UNITED STATES PATENT AND TRADEMARK OFFICE

APPLICATION NO.	FILING DATE	FIRST NAMED INVENTOR	ATTORNEY DOCKET NO.	CONFIRMATION NO.
09/918,886	07/30/2001	Ting K. Yee	20852-05682	3294

Office Action Summary

Drawings

FIG. 1

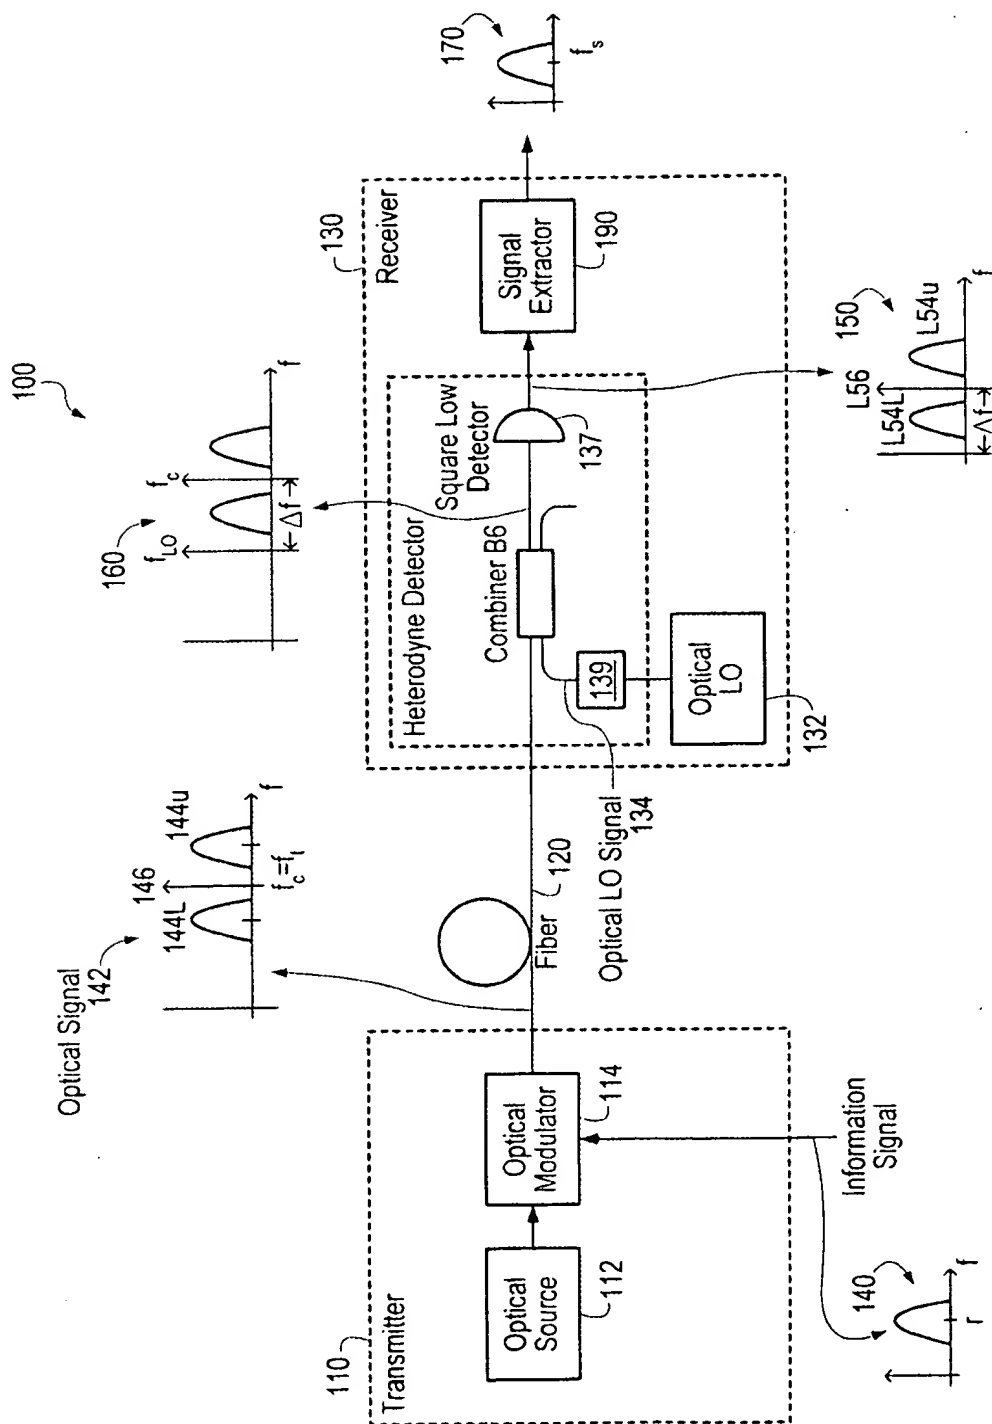
In Fig. 1, replace the frequency label "r" with "f_s" under the spectrum 140. See paragraph [0056] for support.

In Fig. 1, label the heterodyne detector with "180" as in the old Fig. 1 filed on 30 July 2001. See paragraph [0055] for support.

In Fig. 1, replace reference characters "L54L", "L54u", and "L56" with "154L", "154u", and "156", respectively, as in old Fig. 1 filed on 30 July 2001. See paragraph [0059] for support.

In Fig. 1, delete " f_s " under the reference character "170". Paragraph [0059] teaches that component 170 may be offset from f_s instead of being located at f_s as shown in Fig. 1.

In Fig. 1, replace "B6" with "136" and replace "Low" with "Law". See paragraph [0062] for support.

FIG. 2

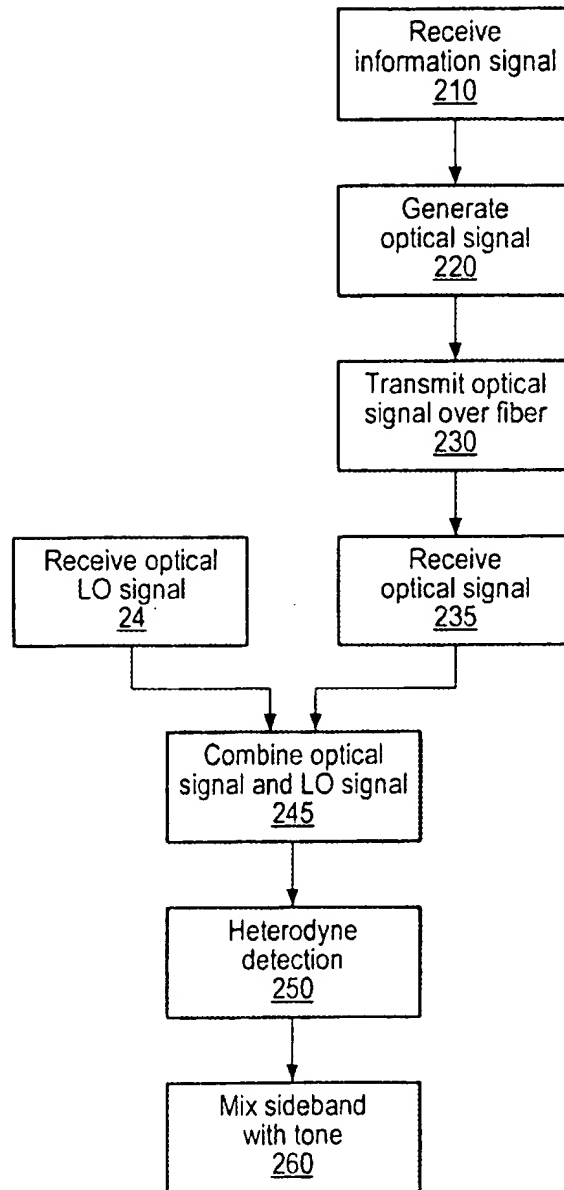
In Fig. 2, add a reference character "200" that points to the entire method. See paragraph [0028] for support.

In Fig. 2, replace reference character "24" with "240" as in old Fig. 2 filed on 30 July 2001. See paragraph [0059] for support.

FIG. 4

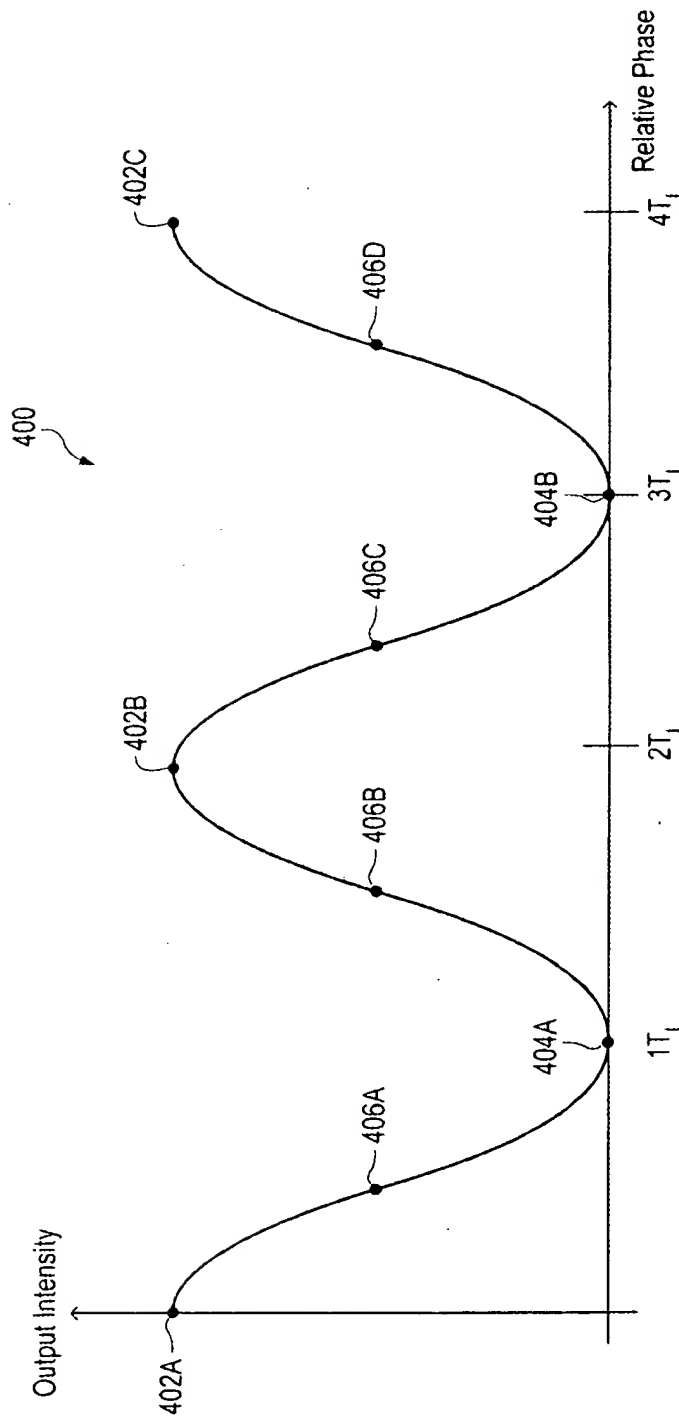
In Fig. 4, replace all instances of " T_1 " with " π " as shown in old Fig. 4 filed on 30 July 2001. See paragraph [0067] for support.

FIG. 5

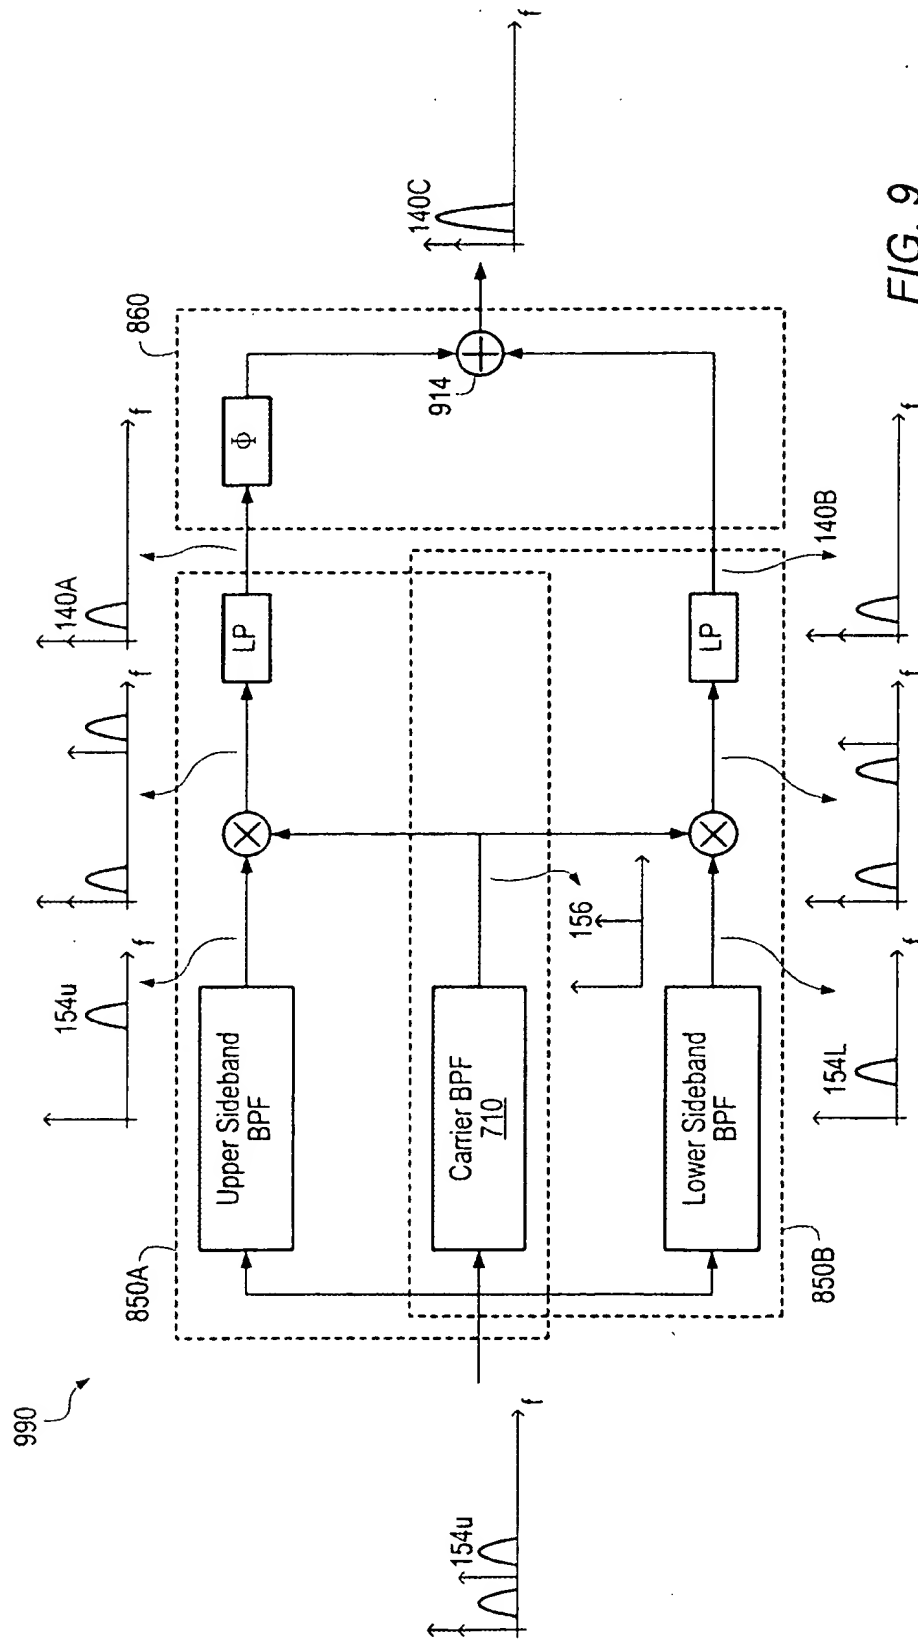
In Fig. 5, replace "Biased off Null" with "Biased at Null" as shown in old Fig. 5 filed on 30 July 2001.

FIG. 10

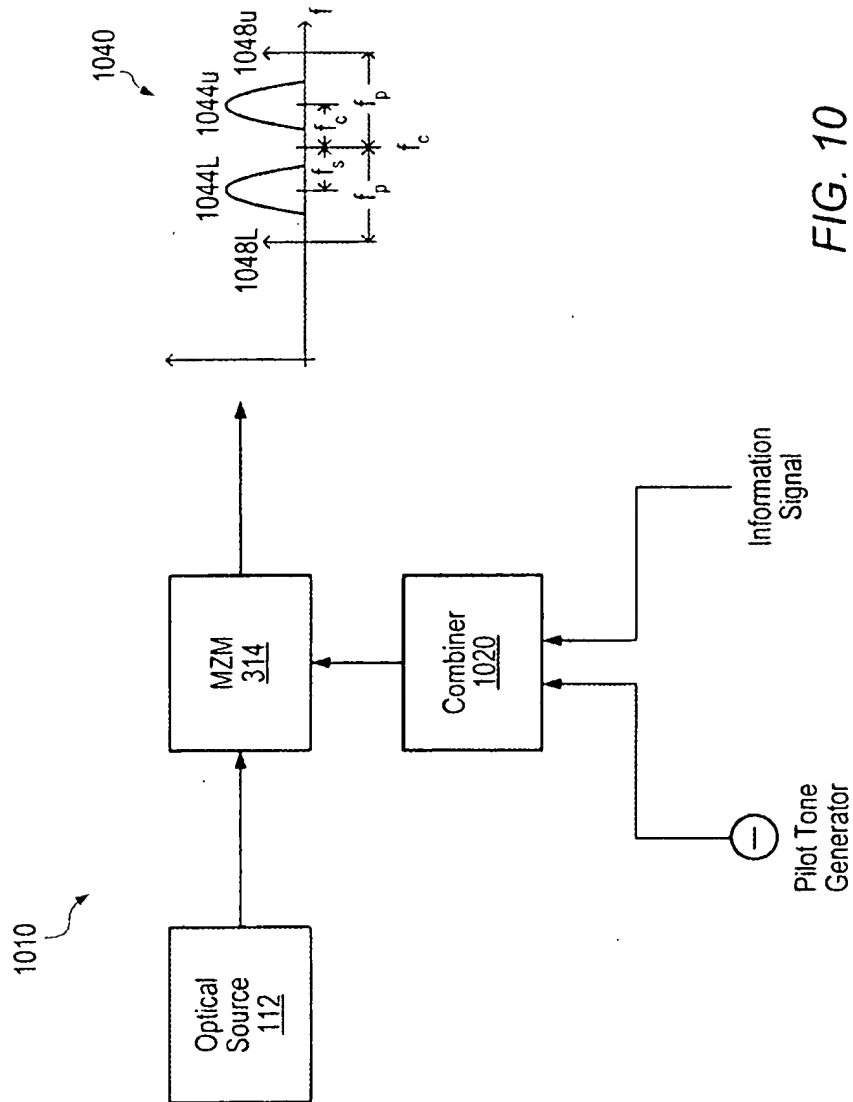
In Fig. 10, label the Pilot Tone Generator with “1030” as in old Fig. 10 filed on 30 July 2001. Also, label the Information Signal with “140” as in old Fig. 10 filed on 30 July 2001. See paragraph [0081] for support.

In Fig. 10, the spectrum drawing shows a label “ f_c ” next to a label “ f_s ”. Replace “ f_c ” with another instance of “ f_s ” so there are two instances of “ f_s ” next to each other as shown in old Fig. 10 filed on 30 July 2001.

FIG. 12

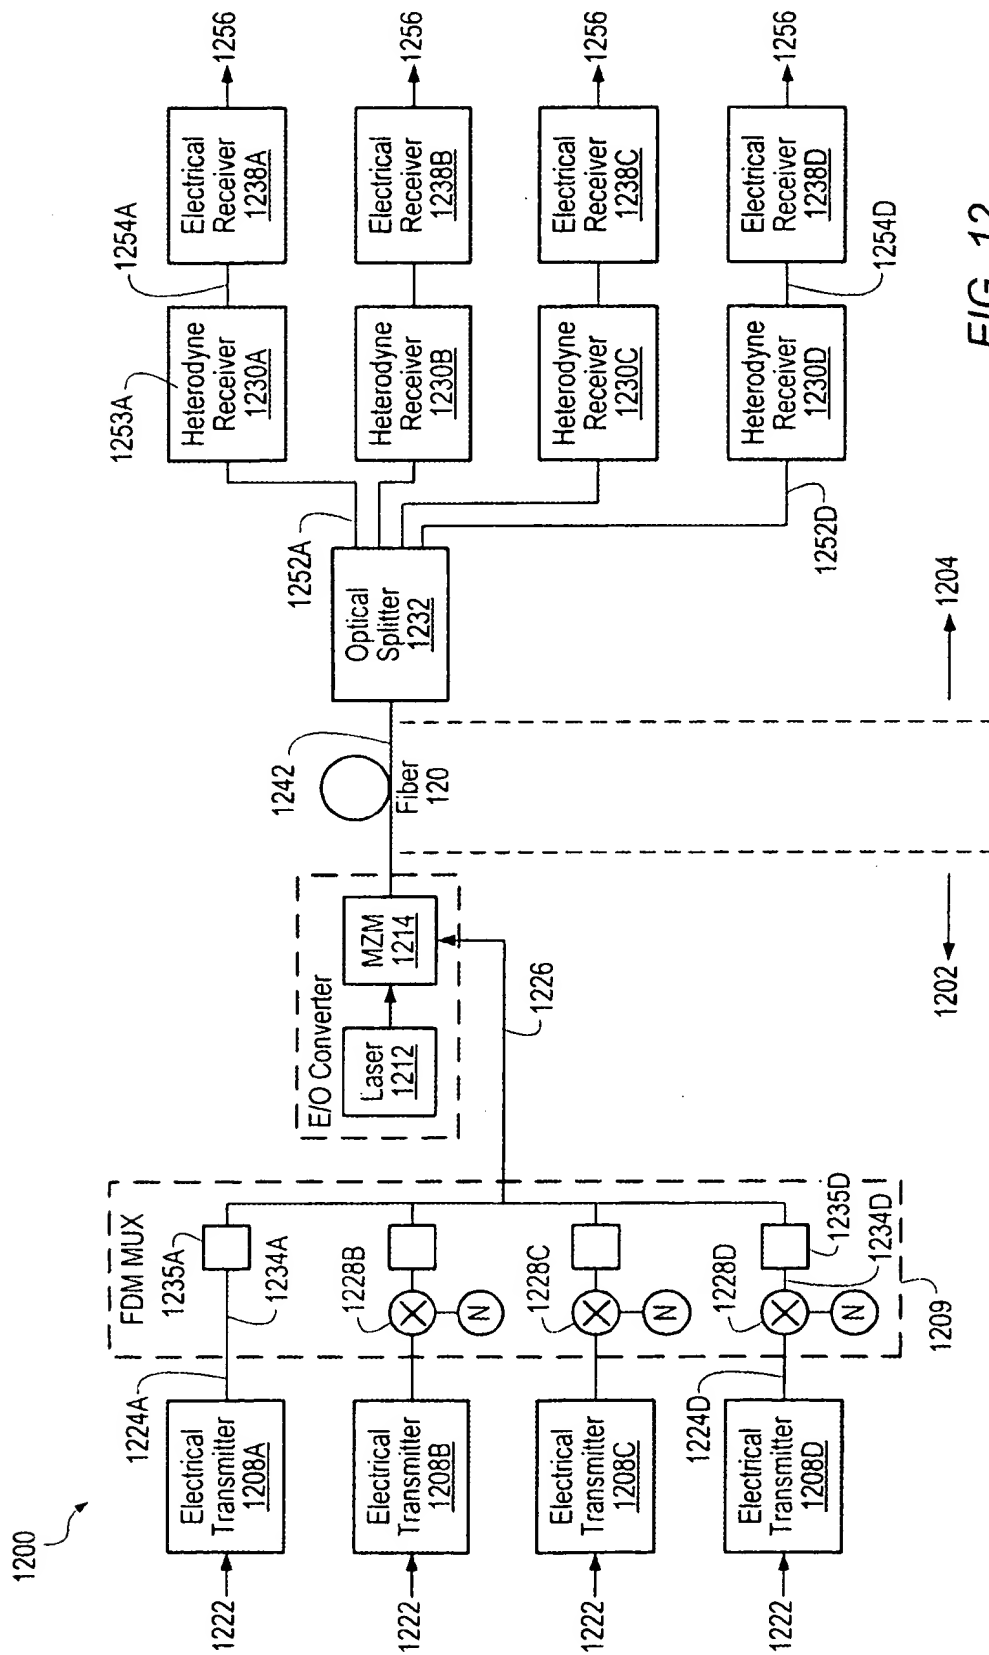
In Fig. 12, label the E/O Converter with “1210” as in old Fig. 12 filed on 30 July 2001. See paragraph [0092] for support.

FIG. 13A

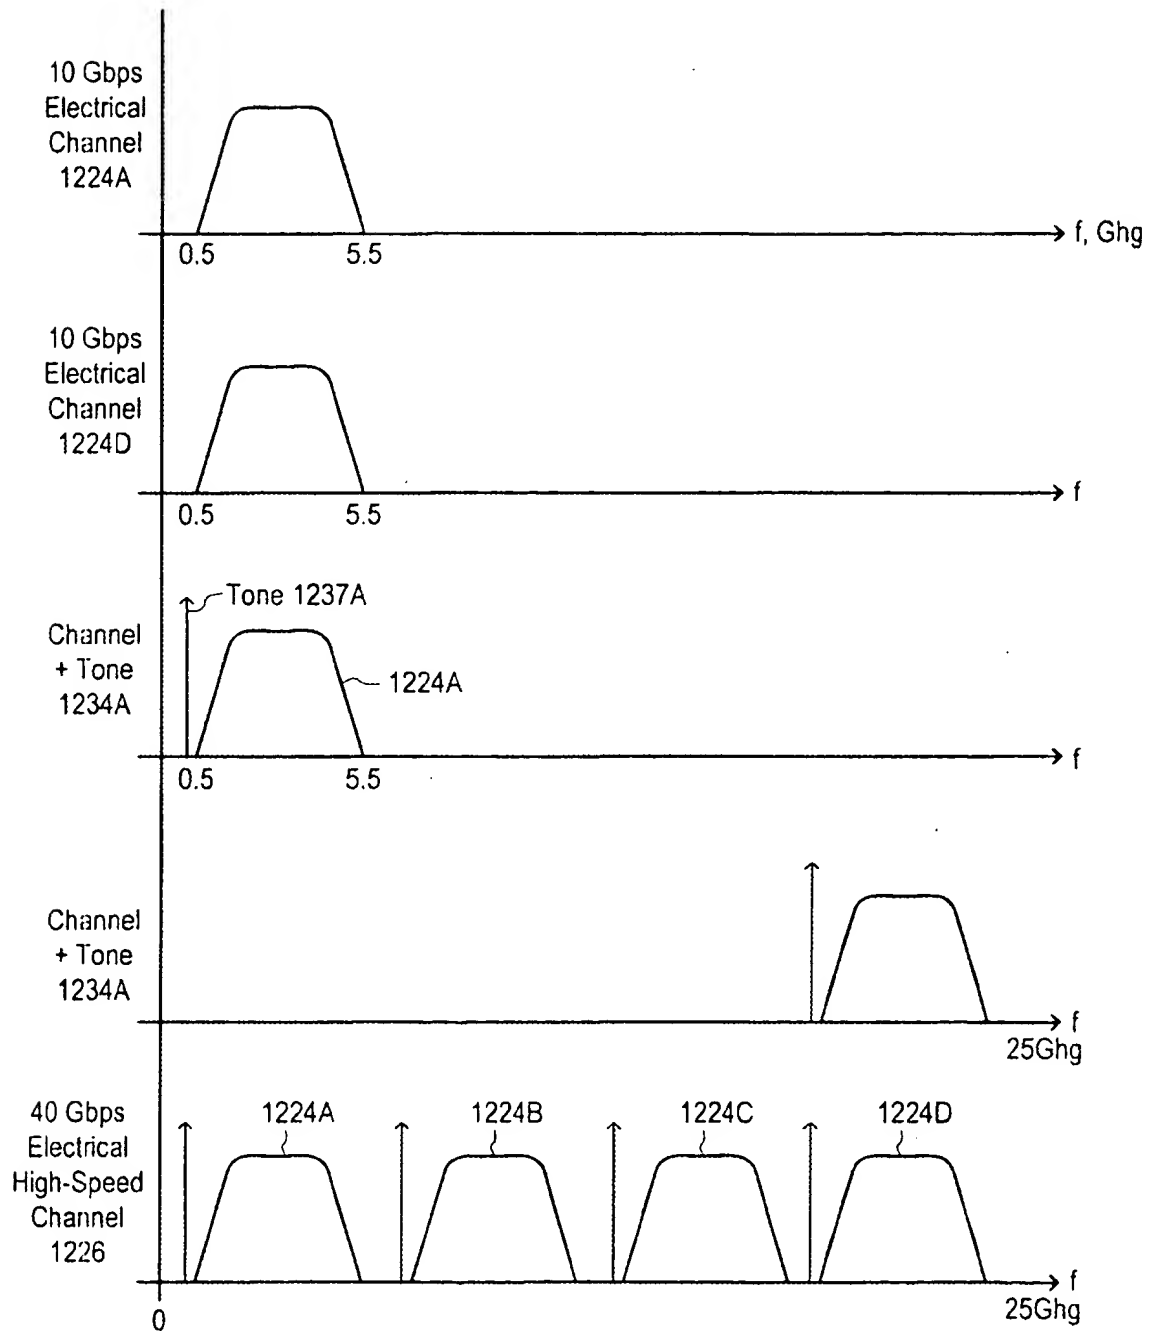
In Fig. 13A, there are two instances of “1234A”. Replace the lower instance with “1234D” as in old Fig. 13A filed on 30 July 2001. See paragraph [0093] for support.

FIG. 13E

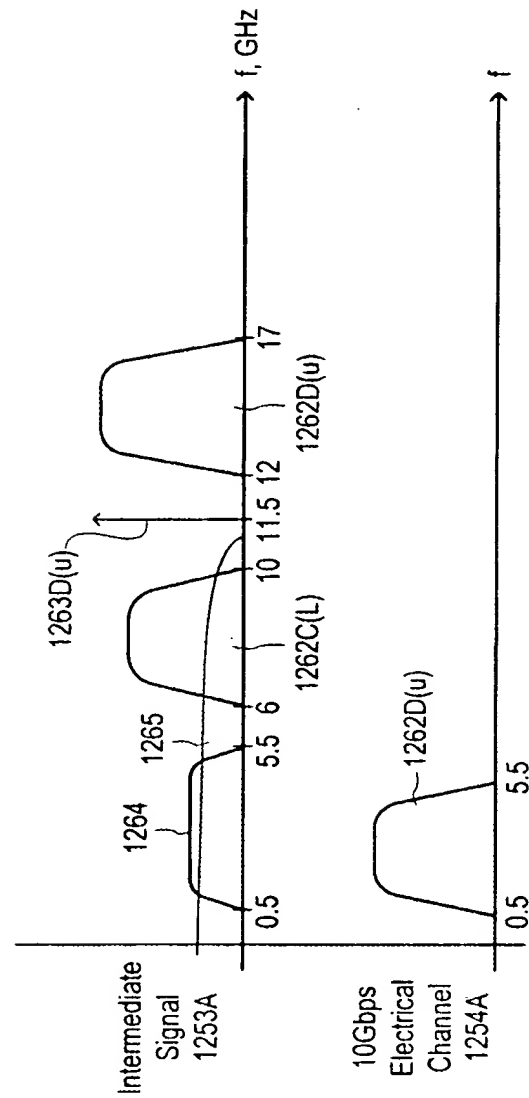
In Fig. 13E, replace “1253A” with “1253D” and replace “1254A” with “1254D” and replace “1262C(L)” with “1262C(U)” as shown in old Fig. 13E filed on 30 July 2001. See paragraph [0103] for support.

FIG. 14A

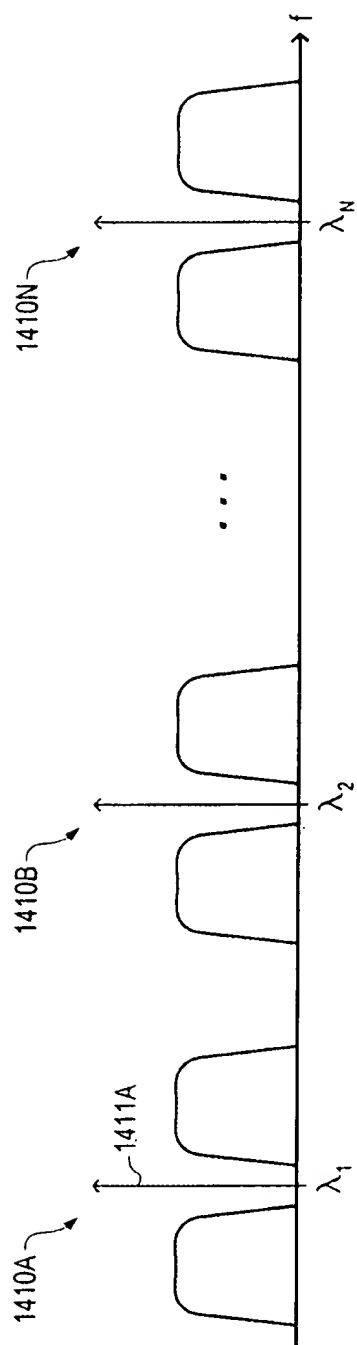
In Fig. 14A, label the lower sideband to the left of optical carrier 1411A with “1412A(L)” and label the upper sideband to the right of optical carrier 1411A with “1412(U)” as shown in old Fig. 14A filed on 30 July 2001. See paragraph [0086] for support.
